DECISION OF THE PLANNING ADMINISTRATOR

**URBAN GROWTH AREA PRELIMINARY DECLARATION / SITE PLAN REVIEW /
ADJUSTMENT / DRIVEWAY APPROACH PERMIT
CASE NO UGA-SPR-ADJ-DAP16-02**

NOTICE OF DECISION DATE: FEBRUARY 02, 2017

APPLICATION SUMMARY: An Urban Growth Area Preliminary Declaration to determine the public facilities required for development of 155 acres and a Site Plan Review, Driveway Approach Permit, and Class 2 Adjustment for a phased office and warehouse development on 43 acres of those 155 acres.

LANCASTER DRIVE STRIPING PLAN 110+00 TO 116+00

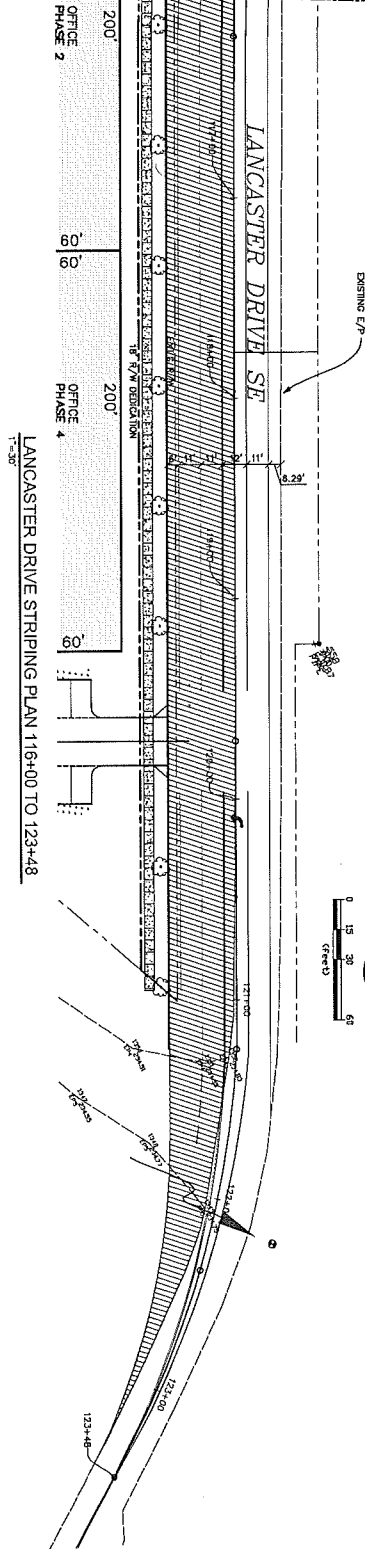
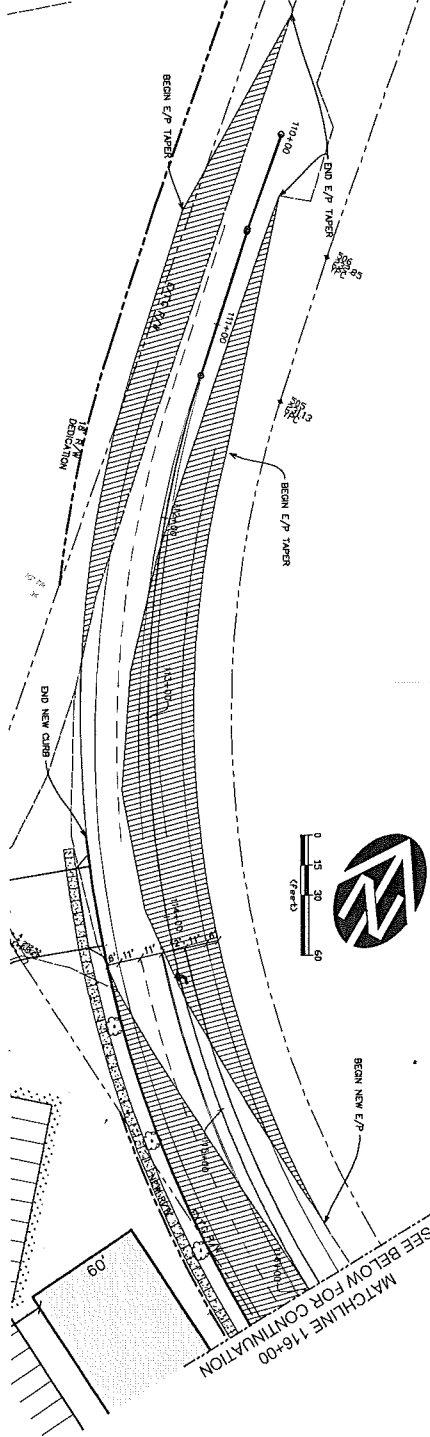
Staff Response: The traffic impacts of the proposed development are being mitigated through construction of a left-turn lane, bike lane, and sidewalk on Lancaster, and through dedication of right-of-way for Lancaster and Carson Drive SE.

- Condition 3:** Along the entire frontage of Lancaster, the applicant shall convey land for dedication of right-of-way to equal 48 feet from centerline and construct a minimum 34-foot-wide half-street improvement to Major Arterial standards. The improvement shall include striping and tapers for left-turn lanes from northbound Lancaster into each of the driveways serving the property.

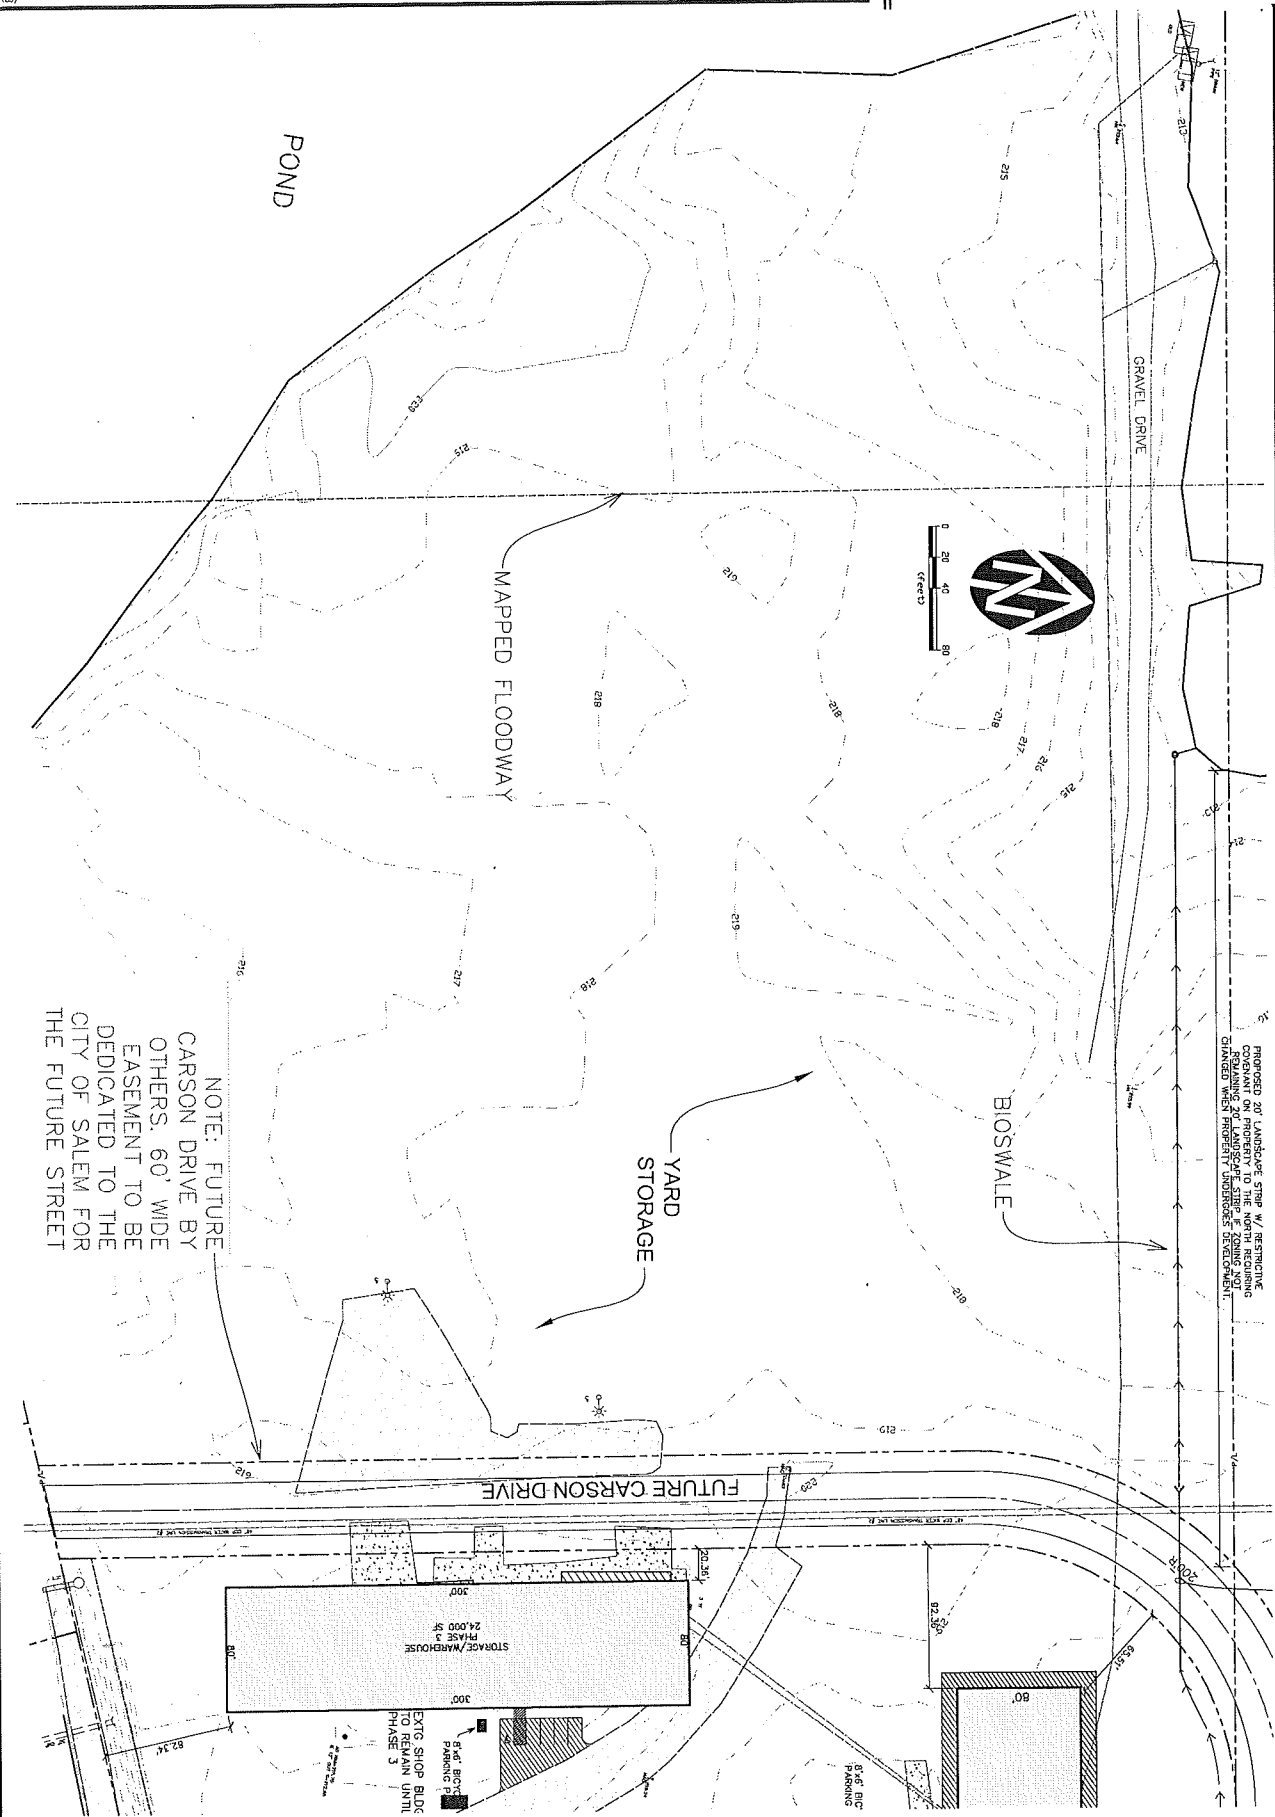
The applicant's site plan indicates one section of proposed 20-foot-wide landscape strip west of the proposed Carson Drive SE right-of-way to the top of bank of the pond and one section approximately 275 feet in length and located east of the proposed Carson Drive SE right-of-way to the Lancaster Drive SE right-of-way. The proposed landscape strip does not include the area between the proposed fuel station and property line and does not extend all of the way to the existing private road. Because vehicular use will be heavy near the fuel station, staff recommends extending the landscaped strip to the existing private road.

The applicant's site plan indicates that the proposed Phase 1 building would be adjacent to the future Carson Drive SE right-of-way. In that area, the roadway will provide physical separation between the proposed use and the abutting RA-zoned property. Street trees meeting the requirements of SRC Chapter 86 (Trees on City Owned Property) will be planted in the future Carson Drive SE right-of-way and will provide a visual barrier between the proposed Phase 1 building and future development north of the right-of-way.

Condition 15: (Phase 1) Provide a 20-foot-wide landscaped area south of the property line separating tax lots 082W0600700 and 082W0600800

from tax lots 082W0600500 and 082W0600600, planted with one plant unit per 16 square feet, from the western edge of the future Carson Drive SE right-of-way to the top of bank, as indicated on the applicant's site plan Sheet C3.1.

Condition 16: (Phase 1) Provide a 20-foot-wide landscaped area south of the property line separating tax lots 082W0600700 and 082W0600800 from tax lots 082W0600500 and 082W0600600, planted with one plant unit per 16 square feet, from the Lancaster Drive SE right-of-way to the existing private road near the fuel station.
